Parks & Recreation Commission Meeting

24-978. Item #3. Consideration of the Revised Schematic Design for the New Public Mini Park at 4590 Patrick Henry Drive.

October 21, 2024

Schematic Design Comparison

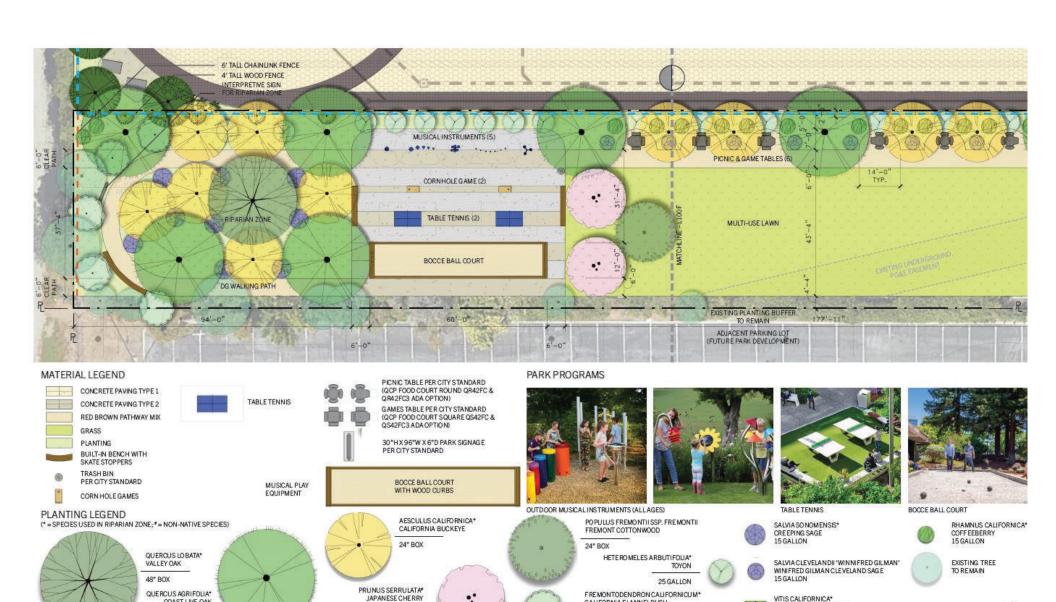
- Maintains the same park elements as the initial schematic design.
- Initial design includes features requested by the community:
 - Children's activities
 - Pedestrian pathways
 - Outdoor seating for gathering
 - Picnic areas
- Revised design incorporates the developer's riparian mitigation obligation at the west side of the park.

- Due to the site location of the residential building, the developer is required to provide mitigation to offset the project's impact on the ecological functions and values of the riparian corridor.
- Developer has been unable to secure mitigation offsite.
- City agreed to accept the developer's riparian mitigation obligation of 0.14-acres within the park parcel.
- Given the concession to accept the mitigation in the park, no additional credit against the project's parkland dedication requirement will be provided.
